IREDELL COUNTY HEALTH DEPARTMENT

IMPROVEMENT PERMIT / AUTHORIZATION TO CONSTRUCT / OPERATION PERMIT / EXISTING SYSTEM INSPECTION

PERMIT# 1366601 PIN# 4711-20-6392 DATE 3-20-08

SUBDIVISION HARBOR WATCH BLOCK / SECTION I LOT 37 LOT AREA 0.779 ACRE SITE CLASS PS DESIGN FLOW 600 L.T.A.R. 0.30 GAD/Ft²

AS BUILT SKETCH

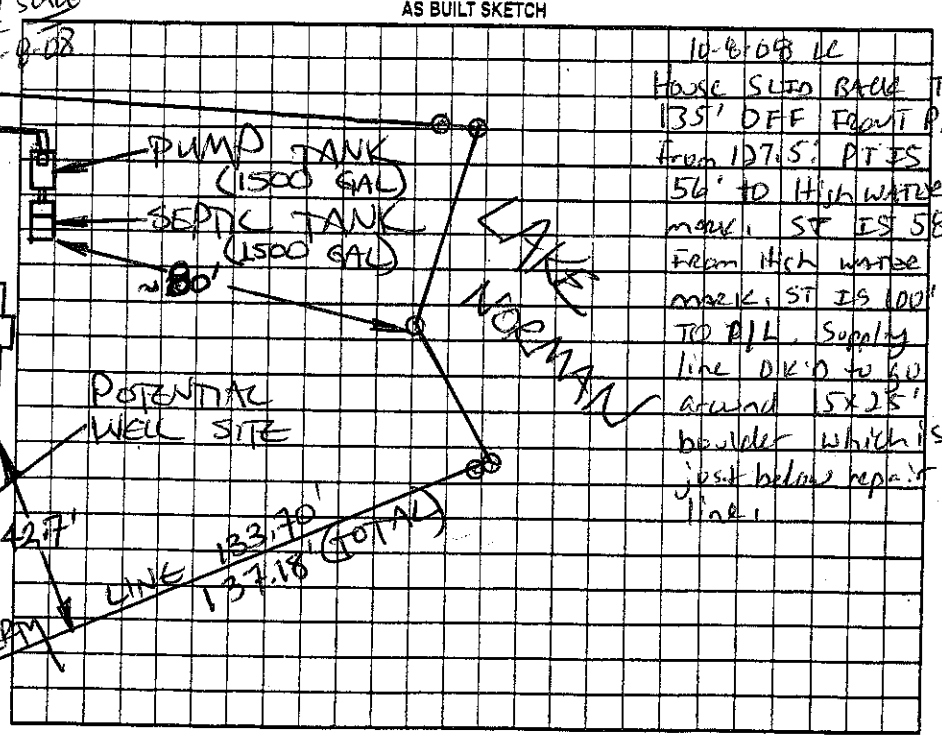
135 Hse to Plc 105 Exp + plc 56. 58' TANK IS 100' From P/L

10-8-08 LC
HOUSE SLID BACK TO 135' OFF FRONT P/L From ID 7.5. PTES 56' TO High WATER mark. ST IS 58' From High water mark. ST IS 100' TO P/L. Supply line DIG'D to KO around 15x25' boulder which is just below repair line.
